PROJECT # 2019-179  
DATE: 28 AUGUST 2020

△ PLAN REVIEW 11.03.2020  
△ PLAN REVIEW 03.19.2021  
△ PLAN REVIEW 05.10.2021

MCKINNEY LANE APARTMENTS PHASE II  
RUSSELL DRIVE & MCKINNEY LANE  
LEBANON, OREGON 97331

△  
BLDG 'A'  
1 SECOND FLOOR - LIGHTING PLAN  
E2.02 SCALE: 1/4" = 1'-0"

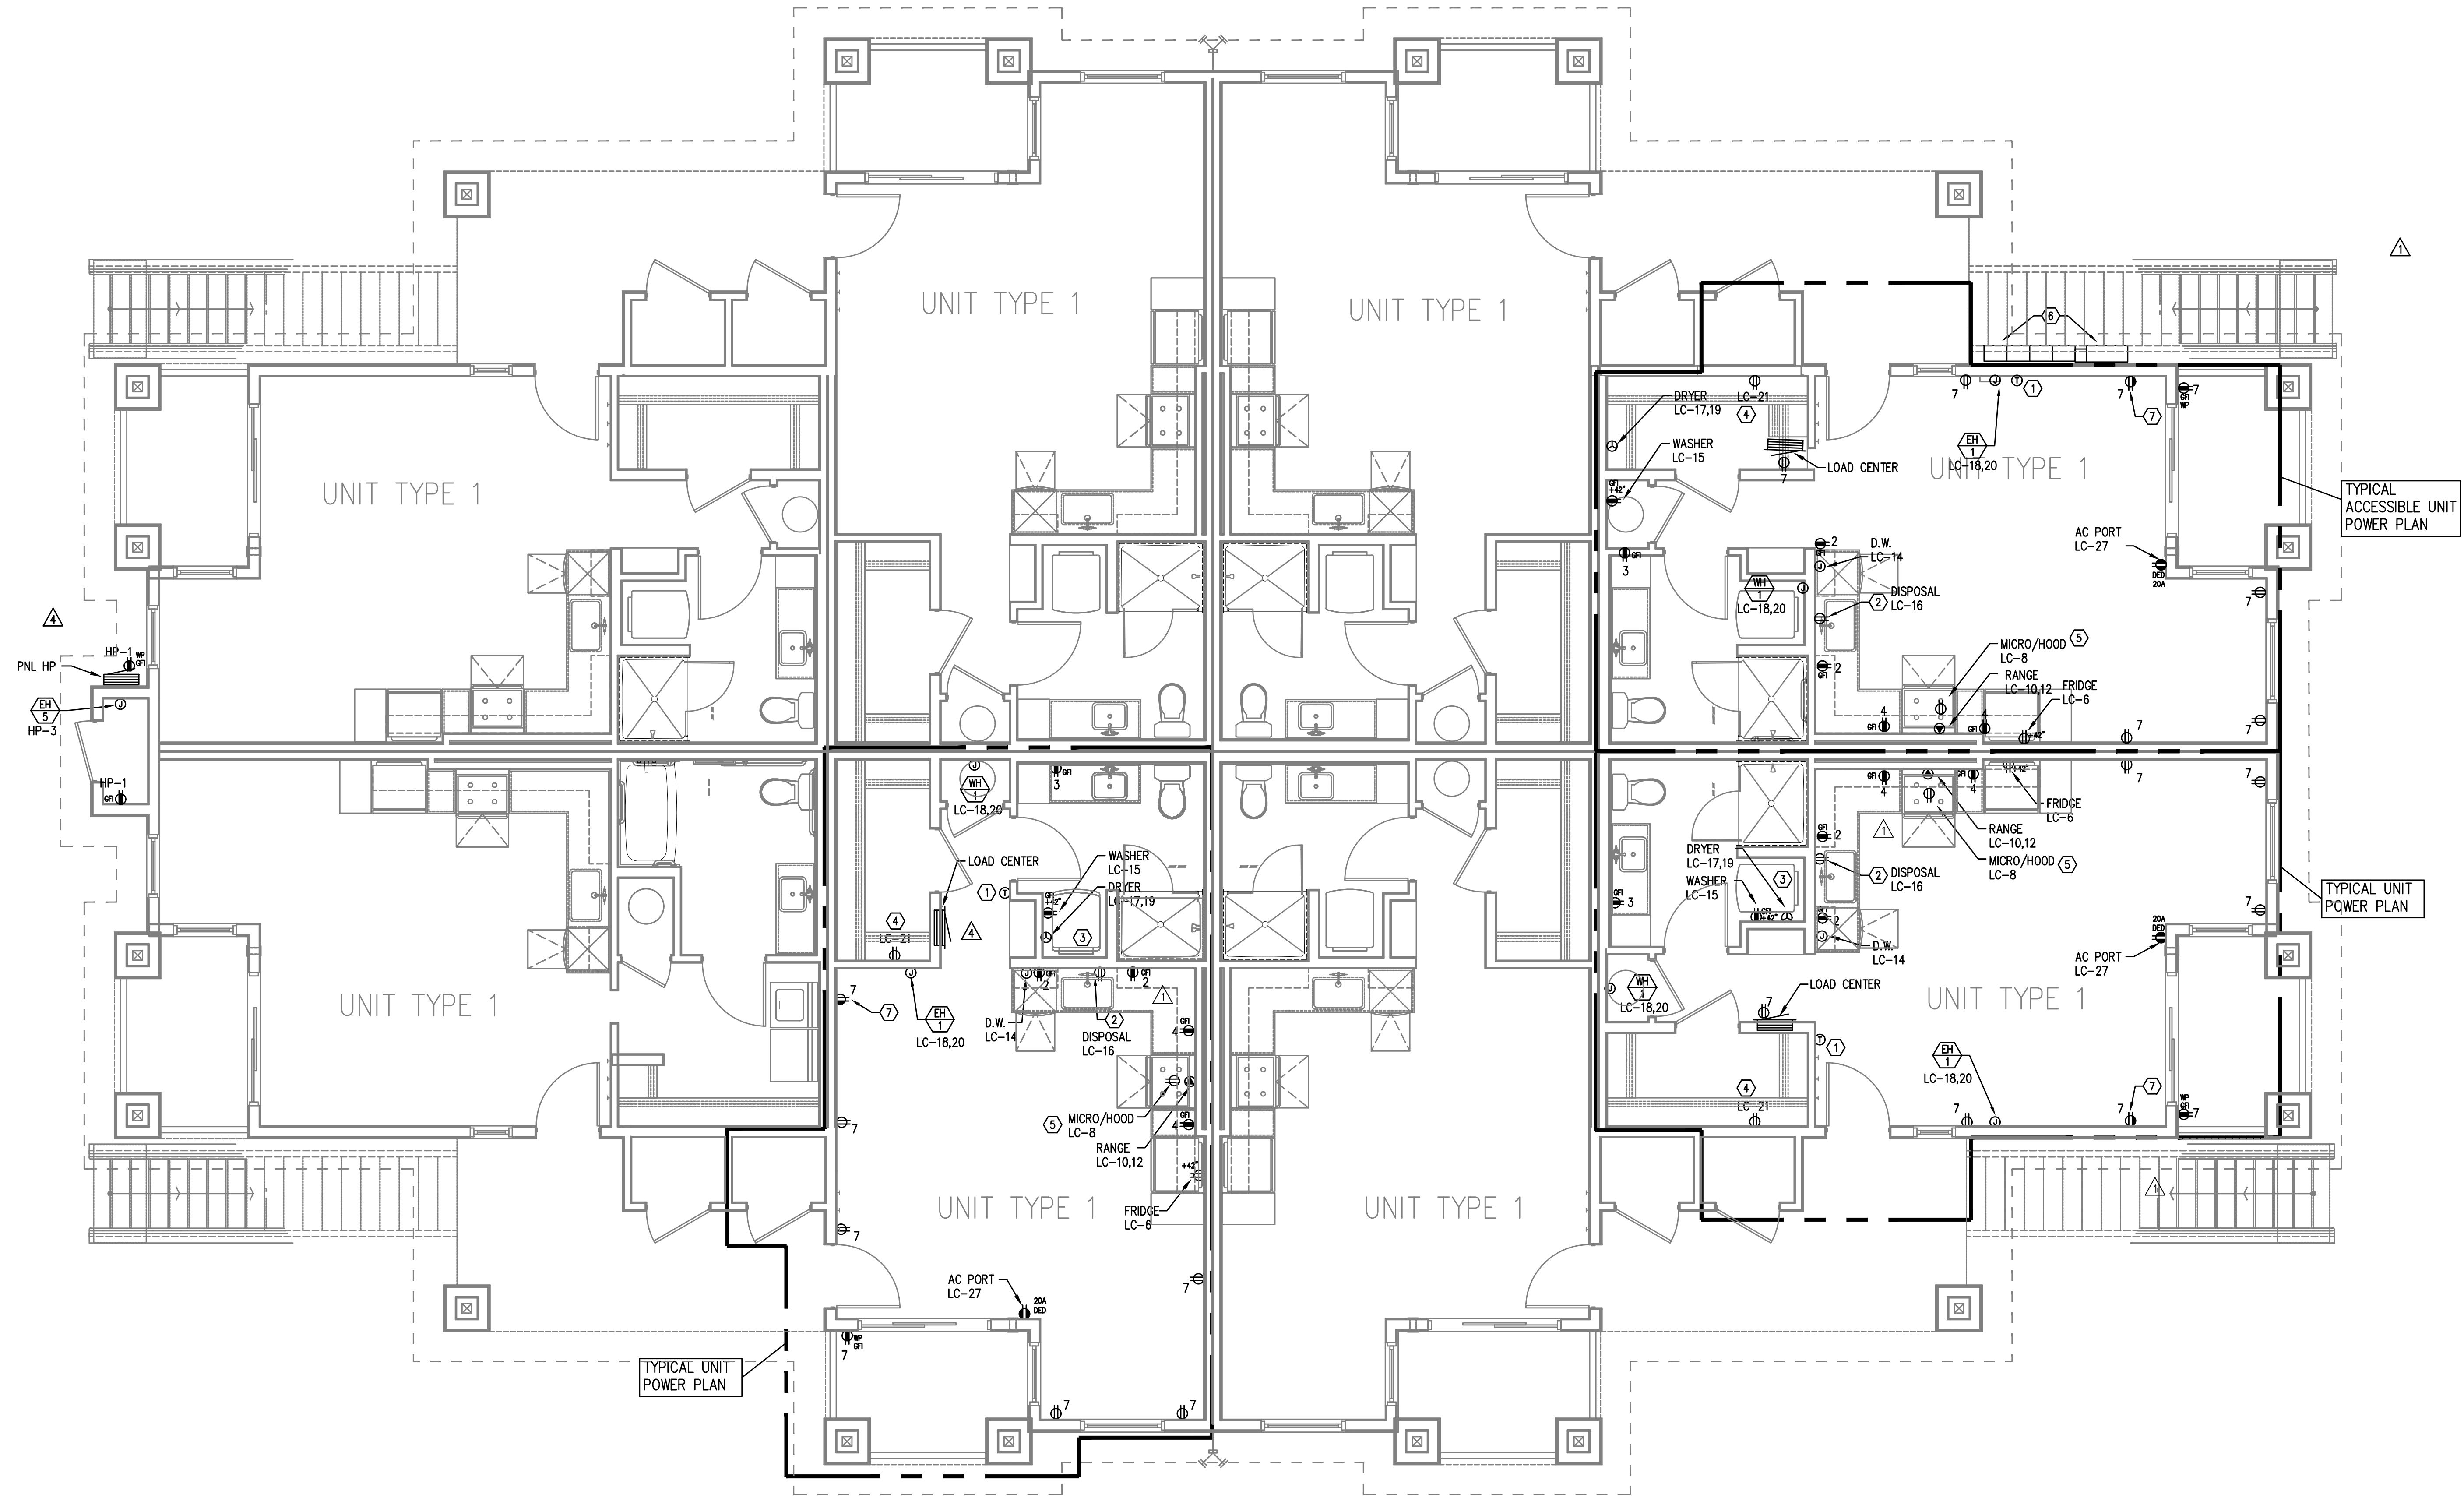
- △ B. ALL DISCREPANCIES SHALL BE BROUGHT TO THE ATTENTION OF THE ARCHITECT IMMEDIATELY UPON DISCOVERY.
- C. REFER TO SHEET E1.21 FOR LIGHT FIXTURE SCHEDULES.

- △ D. THE ELECTRICAL CONTRACTOR SHALL REFER TO THE ARCHITECTURAL AND/OR INTERIORS PLAN SETS FOR DIMENSIONED LOCATIONS, MOUNTING HEIGHTS AND FINISHES OF DEVICES AND FIXTURES.

- △ K. REFER TO ARCHITECTURAL PLANS REGARDING "ACCESSIBLE" UNIT LOCATION(S), INTERIOR ELEVATIONS & DETAILS. COORDINATE INSTALLATION OF ALL DEVICES PER THE "AMERICAN DISABILITIES ACT" (ADA). REFER TO SHEET E1.21 FOR STANDARD ADA REACH REQUIREMENTS.

- △ H. CEILING HEATERS SHALL BE PROVIDED AND INSTALLED BY THE ELECTRICAL CONTRACTOR. INSTALLATION TO INCLUDE WIRING AND DEVICES FOR REMOTE THERMOSTATS. CONSULT ARCHITECTURAL PLANS FOR EXACT LOCATIONS. REFER TO E1.11 FOR MORE INFORMATION REGARDING THE WALL HEATERS.

△  
BLDG 'A'  
1 SECOND FLOOR - POWER PLAN  
E302  
SCALE: 1/4" = 1'-0"

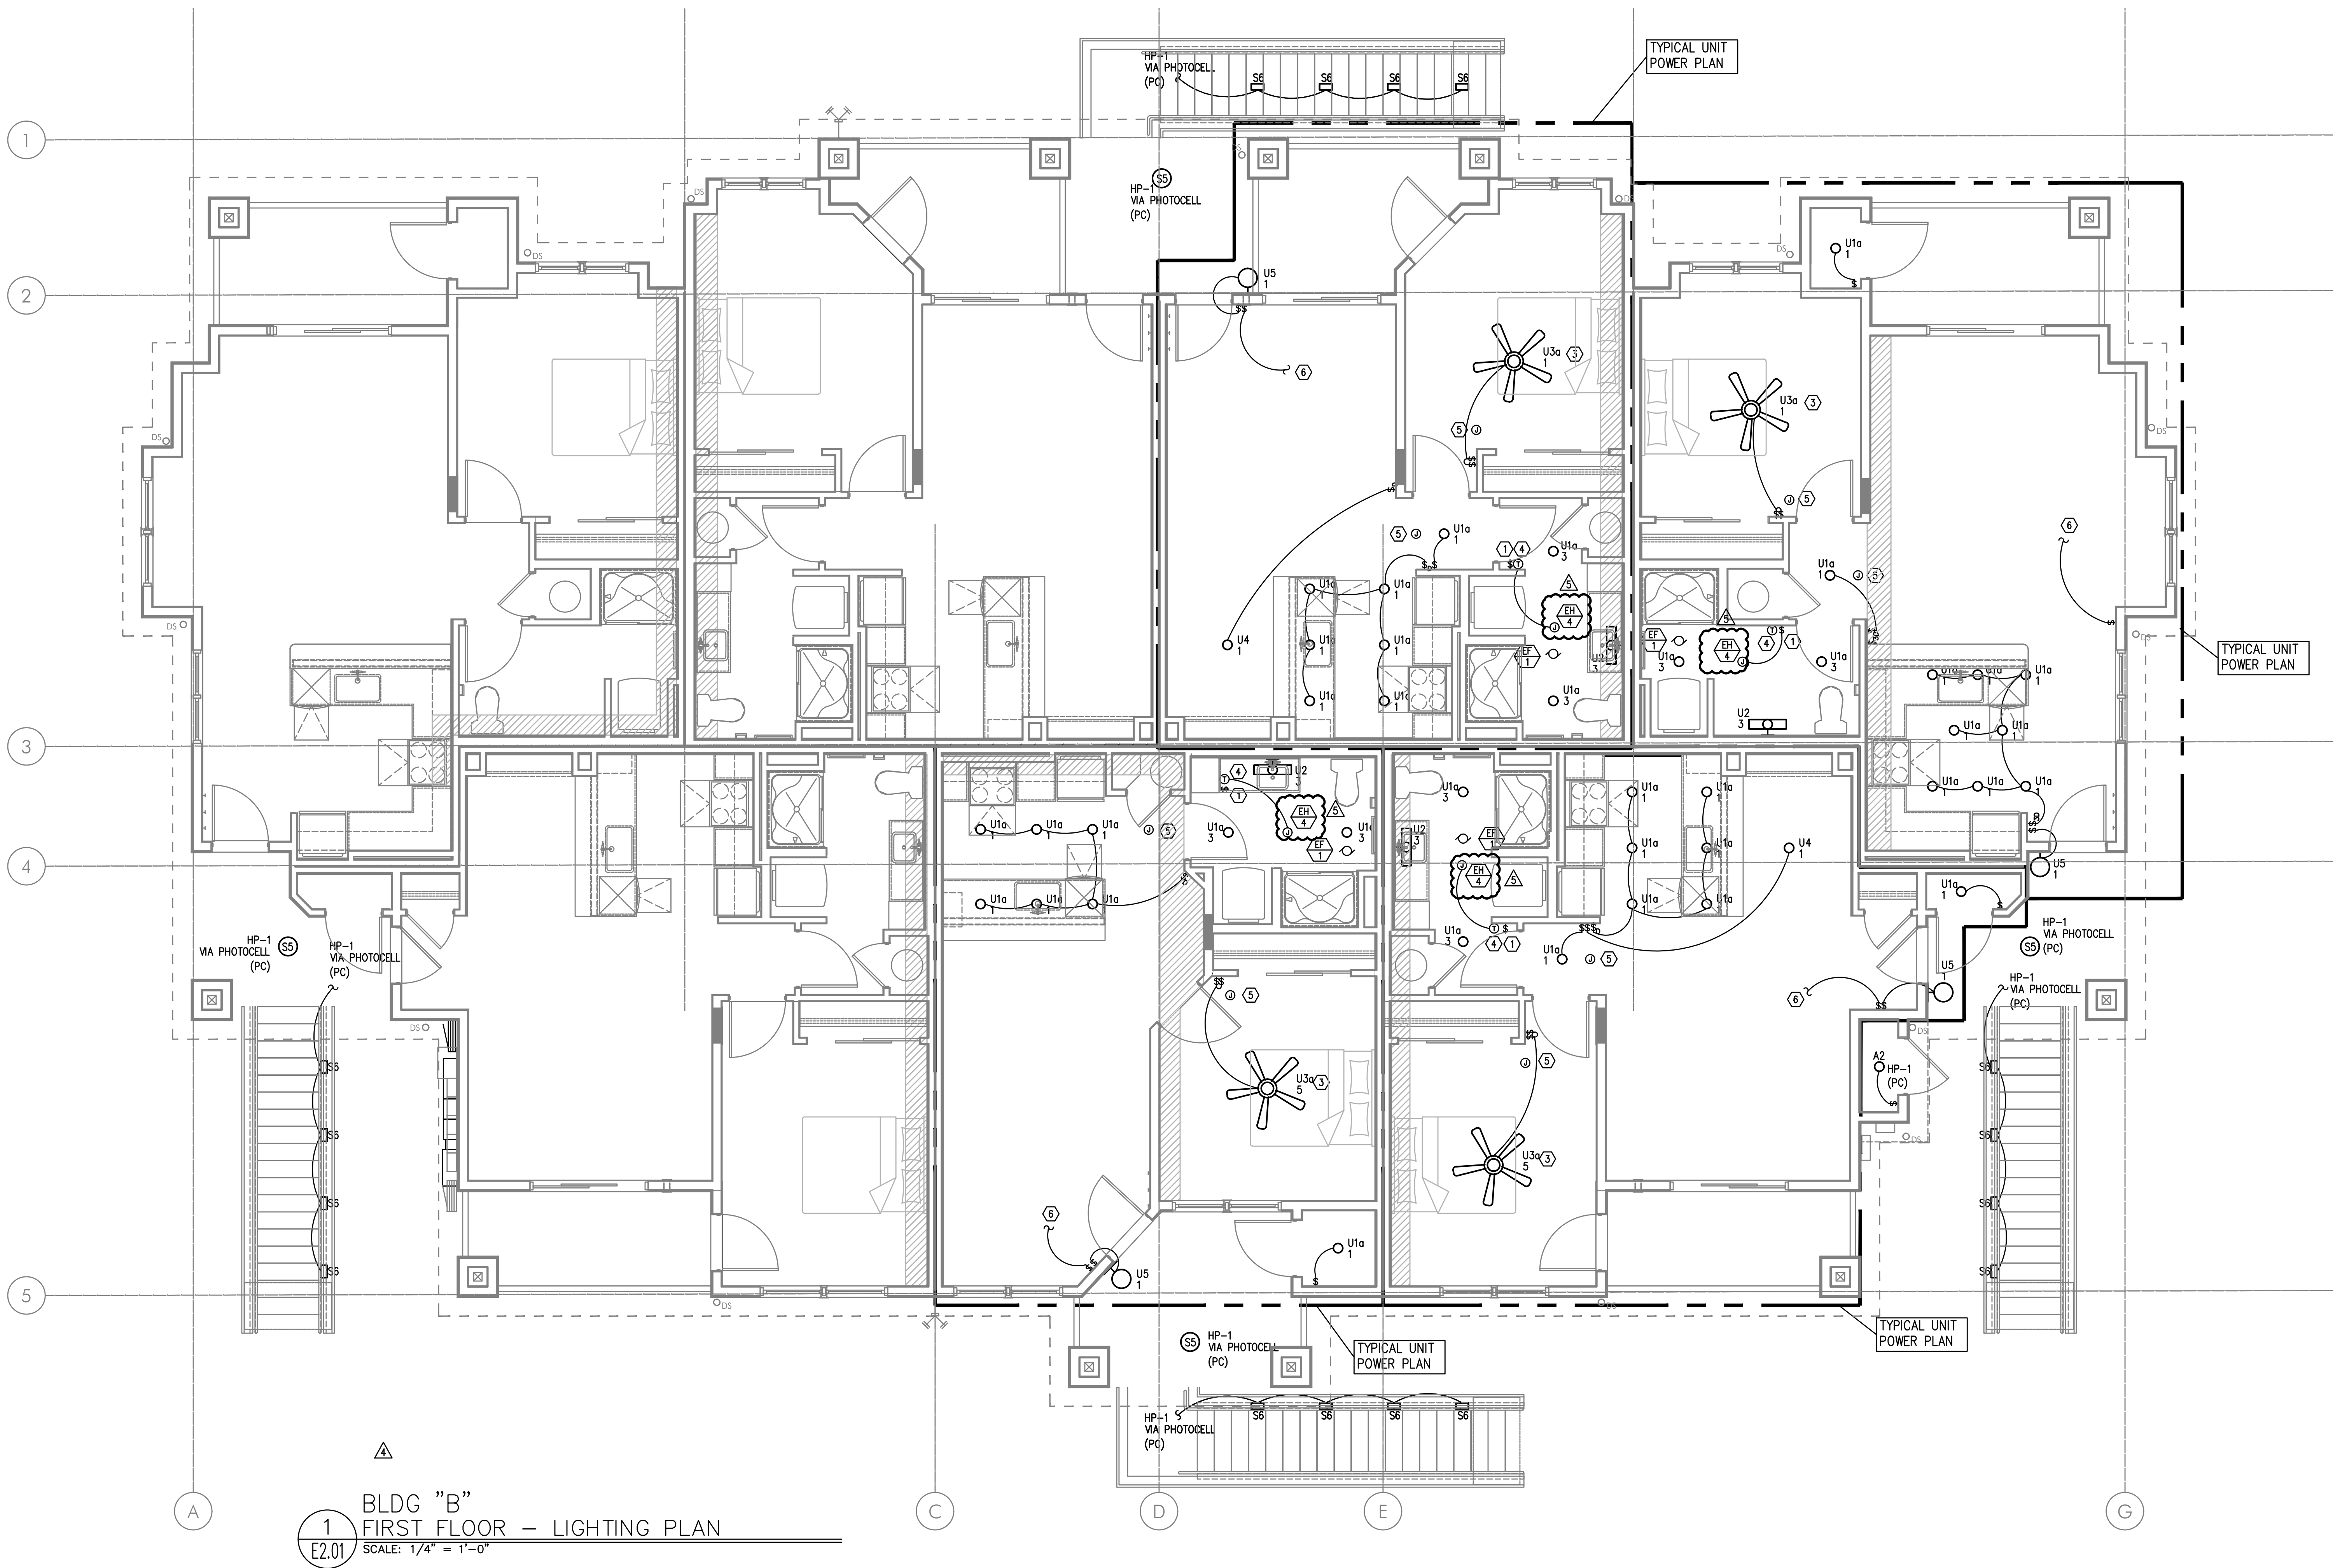
- △ B. NOT USED.
- C. ELECTRICAL CONTRACTOR SHALL PROVIDE INSTALLATION AND FINAL CONNECTION OF THERMOSTATS. CONSULT MECHANICAL CONTRACTOR FOR EXACT REQUIREMENTS PRIOR TO ROUGH IN.

- △ G. REFER TO ARCHITECTURAL PLANS REGARDING "ACCESSIBLE" UNIT LOCATION(S), INTERIOR ELEVATIONS & DETAILS. COORDINATE INSTALLATION OF ALL DEVICES PER THE "AMERICAN DISABILITIES ACT" (ADA). REFER TO SHEET E1.21 FOR STANDARD ADA REACH REQUIREMENTS.

- △ H. WALL HEATERS SHALL BE PROVIDED AND INSTALLED BY THE ELECTRICAL CONTRACTOR. INSTALLATION TO INCLUDE WIRING AND DEVICES FOR REMOTE THERMOSTATS. CONSULT ARCHITECTURAL PLANS FOR EXACT LOCATIONS. REFER TO E1.11 FOR MORE INFORMATION REGARDING THE WALL HEATERS.

- △ 1. PROVIDE WIRE CONNECTION FOR THERMOSTAT(S). COORDINATE WITH ARCHITECT FOR EXACT LOCATION PRIOR TO ROUGH IN. REFER TO ARCHITECTURAL INTERIOR ELEVATIONS FOR DIMENSIONED LOCATIONS OF THERMOSTATS. REFER TO SHEET E1.11 FOR MORE INFORMATION REGARDING WALL HEATERS & T-STATS.
